21-COA-0017
218 W. Oak St.

Old Louisville Architectural Review Committee
Public Hearing

Bradley Fister, Historic Preservation Specialist
April 21, 2021

2 South Facade - Proposed
Scale: NA

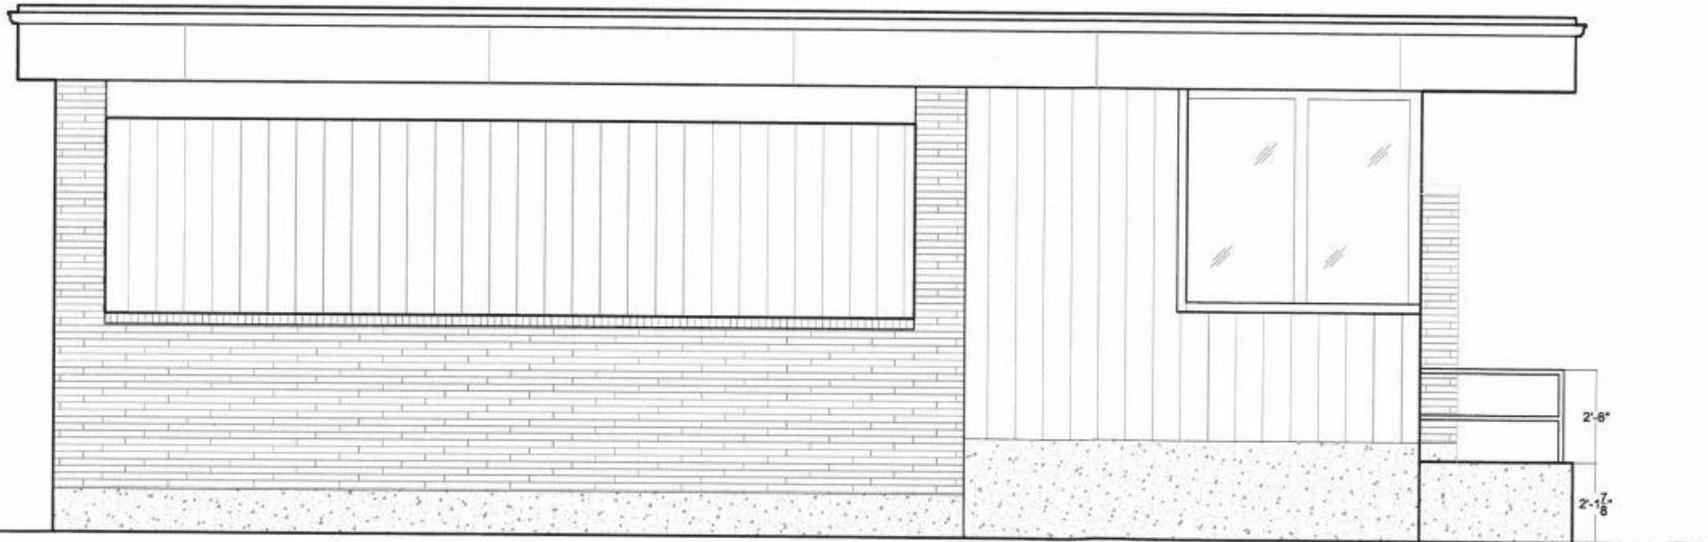
3. The applicant requests approval to remove and replace the existing replacement windows on the north, south, and east facades of the building. The applicant proposes to extend the size of 3 windows on the north façade, to go from floor to ceiling height, as well as to change out the replacement door with a five lite glass entry door. The applicant proposes to remove the paneling and install six new windows within the existing opening on the east façade, as well as to remove the two windows located at the right corner of the east façade, expand the opening, and install three floor to ceiling height windows to match those on the north façade. On the south façade, the applicant proposes to remove the paneling in the existing window opening and install a double entry five lite door with a transom above each.

The proposed window replacement generally does meet the Old Louisville Design Guidelines for **Windows**. **W14** states not to alter the number, size, and location of original windows. The existing windows however are not original, and the sizes of the existing windows have been altered previously.

On the basis of the information furnished by the applicant, Staff recommends the application for a certificate of appropriateness be approved.

1. If the scope of the project were to change, applicant shall contact staff for approval.
2. The applicant shall use historic concrete mix, for any and all concrete visible from the street
3. The applicant shall provide staff with a window cut sheet for the proposed window change prior to work commence.
4. The applicant shall obtain any and all necessary work permits.

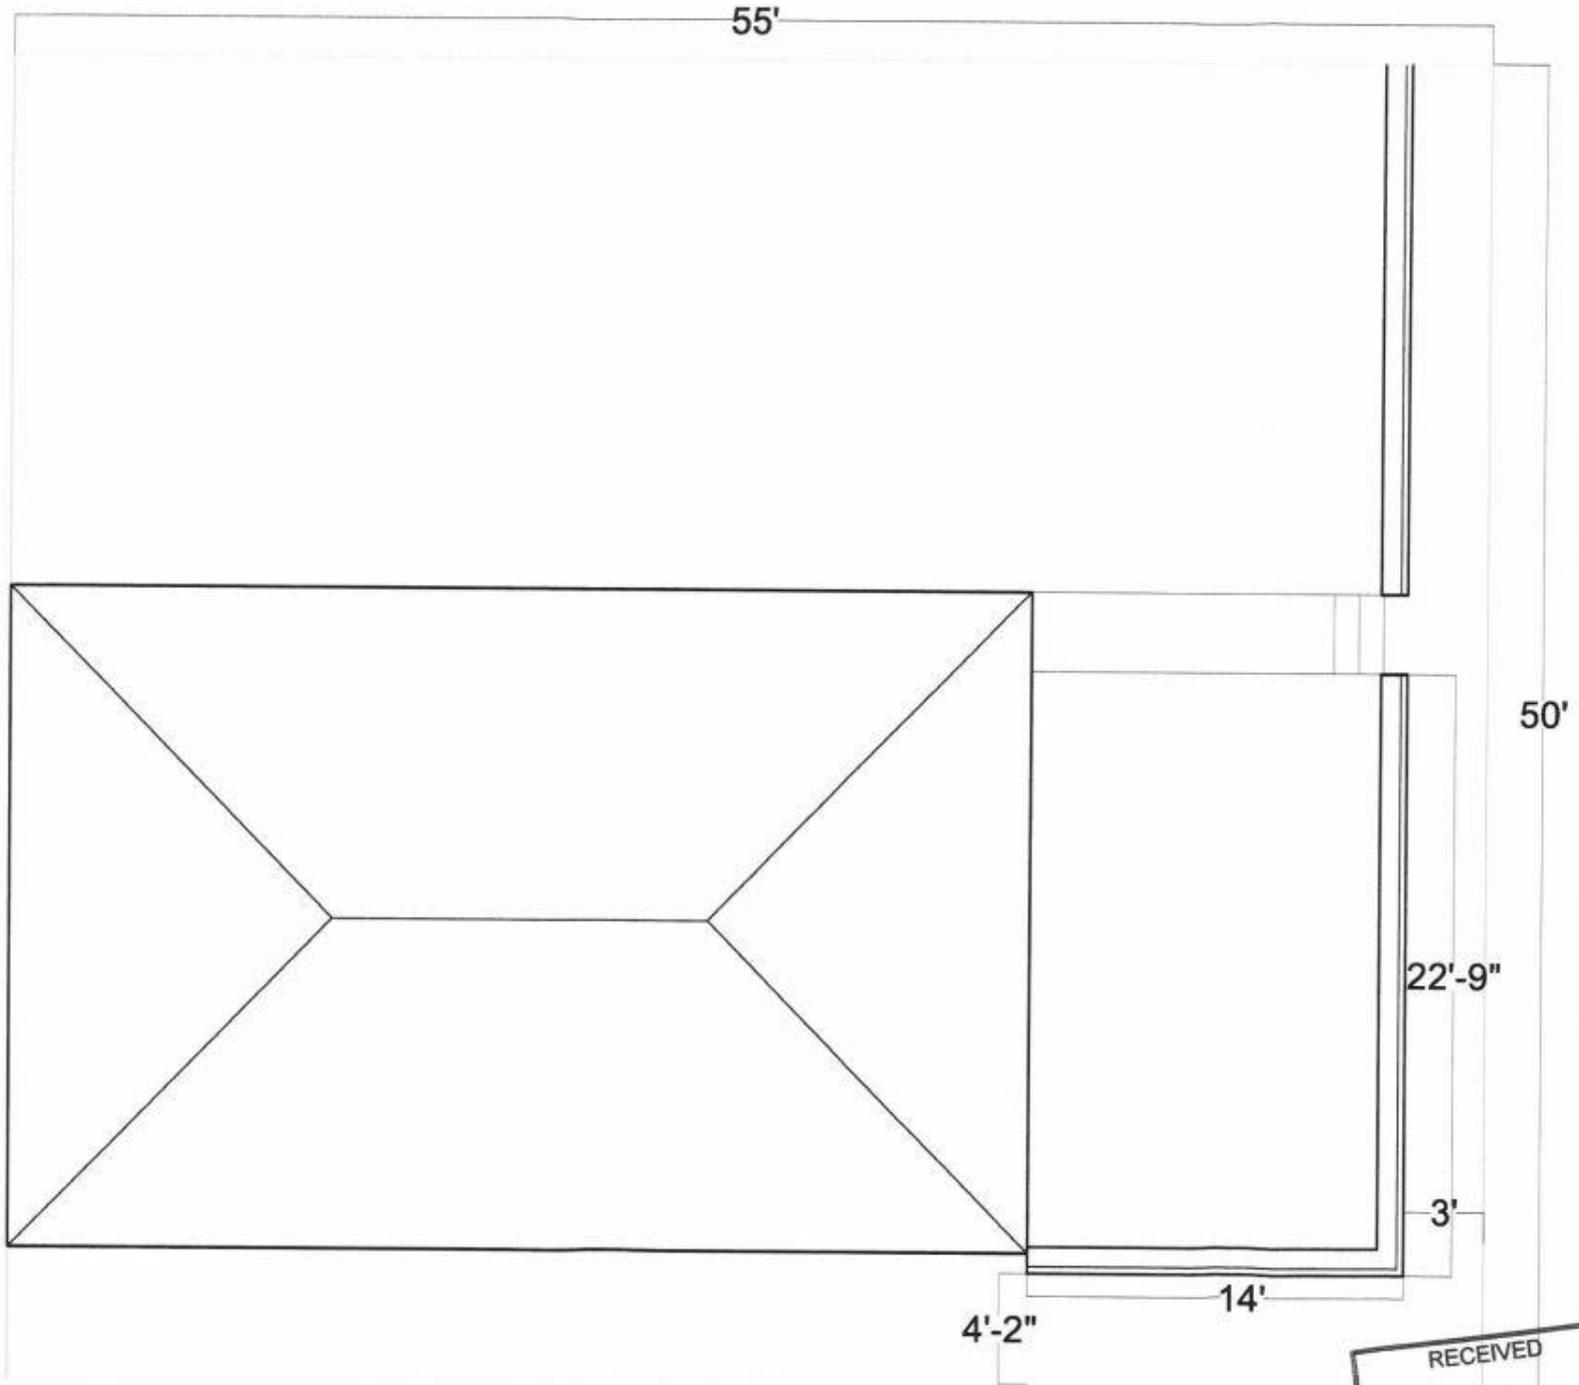
The proposed location of the retaining wall and fencing (Part 1) are primarily along the front of the building that faces W. Oak St. The proposed fencing and retaining wall generally do not meet the Old Louisville Design Guidelines for **Site**. The primary conflict with the Design Guidelines relates to **ST8** which states to maintain the original front yard topography, **ST10** which states not to install masonry walls in street visible locations unless they are used to retain earth or there is an historic precedent **ST13** and **ST14** which states not to install front-yard fencing where there is no historic precedent, and historically-compatible iron fencing should be under 2' - 5".

On the basis of the information furnished by the applicant, Staff recommends the application for a Certificate of Appropriateness be **denied**.
